Draft

June 29, 2000

2000 Regional Transportation Plan Public Comment Report

*Summary of public comments received
between May 15, 2000 – June 29, 2000*

PLAN VIEW NTS
 for
 DAVIS PROPERTY DRAIN

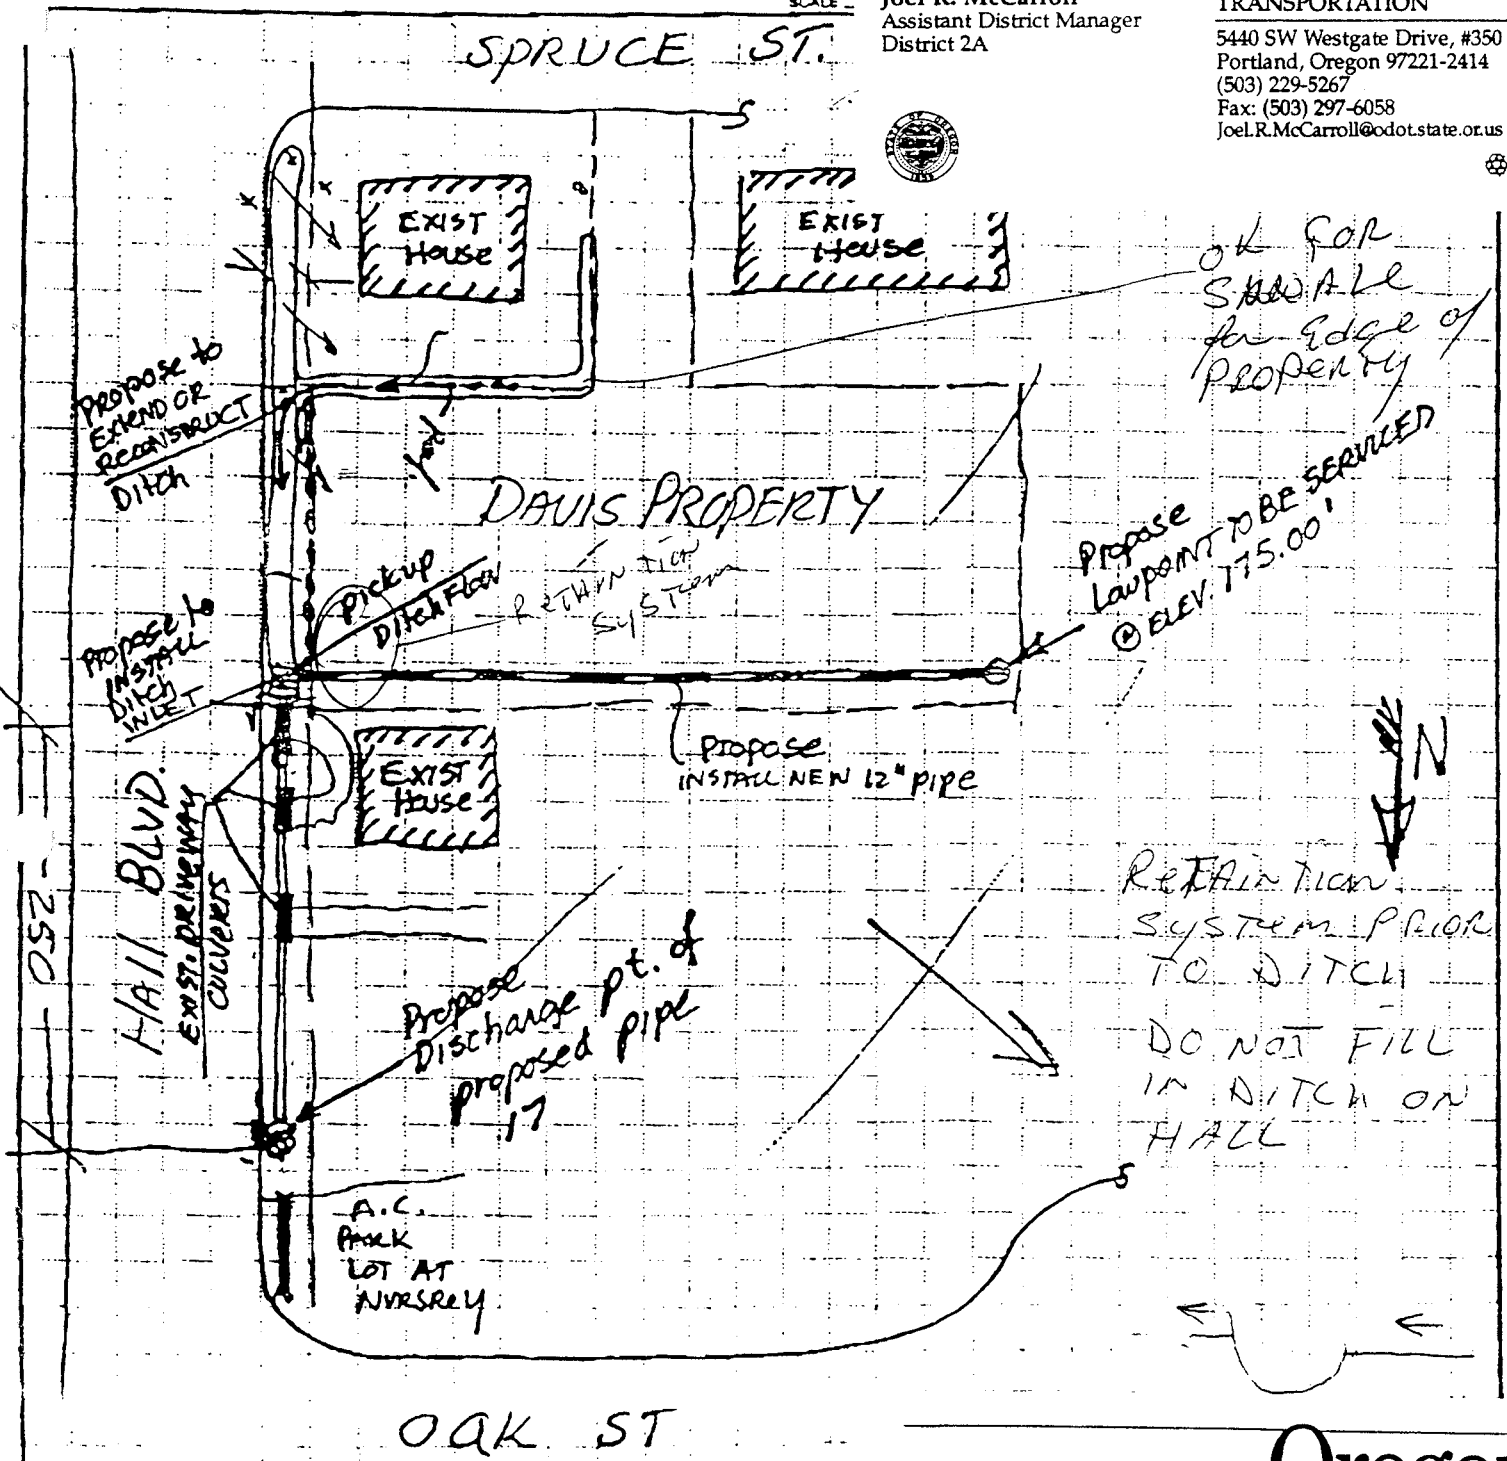
The city of Tigard flagged our lot because of a drainage water problem. Our neighbors would not let us drain the water to the creak even though we would pay the costs. As a result, we are land-locked. Our request is that you provide drainage for us when you are building the five-lane highway.

REVISED ALT. #5 NOV. 1999

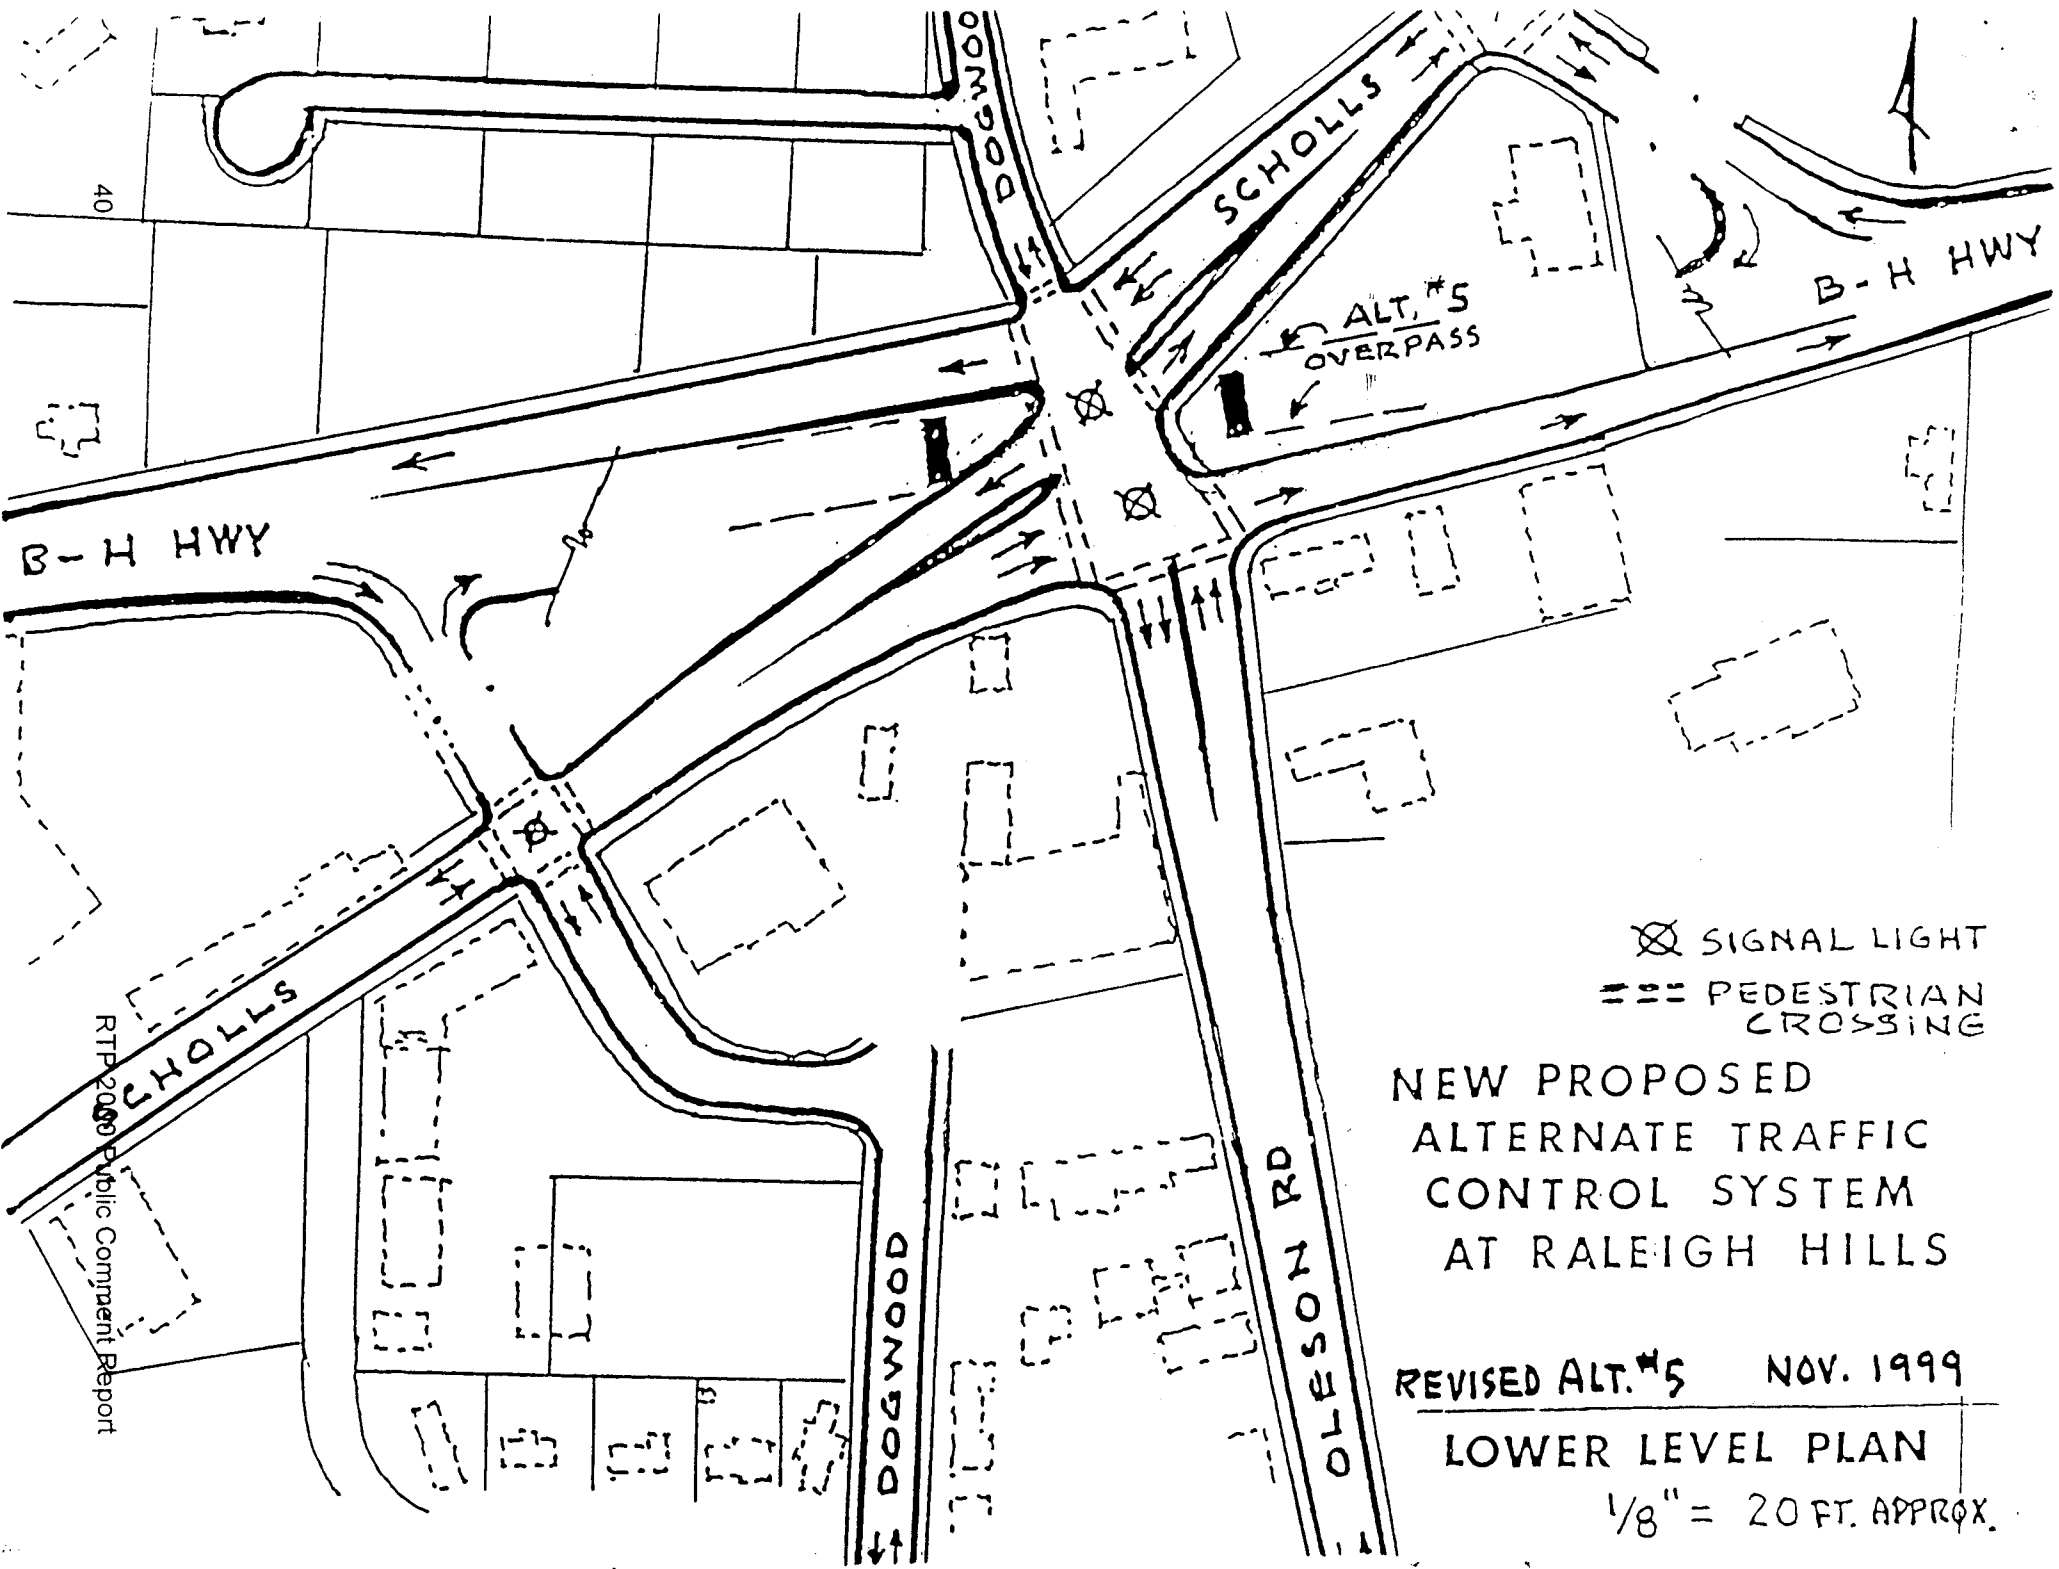
Due to the Town Center planner's desire for a " Boulevard type design " which will reduce State Highway # 10 by two traffic lanes, it is self evident that some version of Alternate No. 5 Over-Pass Design is mandatory to accomplish METRO's goals for this State Regional Transportation Corridor at this location.

A suggested solution could be similar to the enclosed Map showing a proposed "Revised" Alternative No. 5 dated Nov. 1999. Possibly this could be paid for by savings that might result from deleting the rebuilding of the north end of Oleson Road to go east through several businesses and also the new west road off of Oleson going through the expensive PGE transformer substation. With the new design these are not needed.

**Figure 2
PROPOSED MOTOR VEHICLE
FUNCTIONAL CLASSIFICATION**

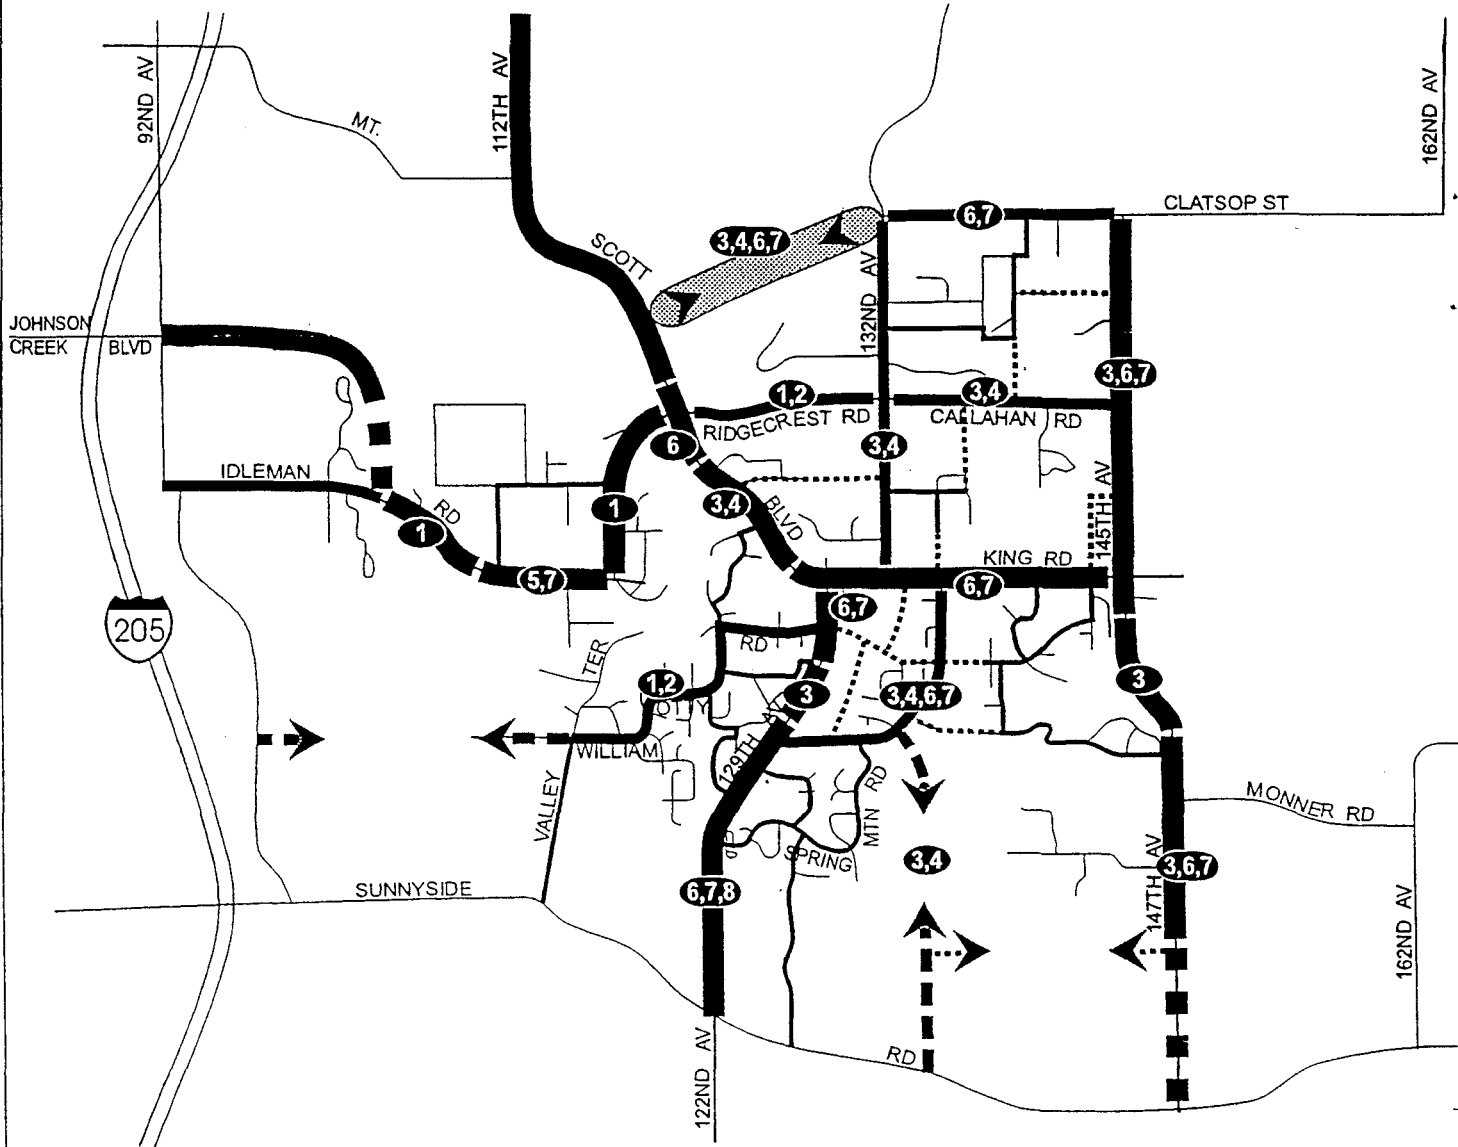
The Happy Valley TSP, adopted December 98, included a proposed "Collector Study Area" between the intersection of SE Clatsop and SE 132nd Ave to SE Mt. Scott Blvd. The reason we didn't actually show this as a collector in our plan was because it is inside the city limits of Portland. However, we did spend some time studying this segment and concluded this is a workable solution to diverting traffic from SE Ridgecrest which is a local street functioning as a substandard collector.
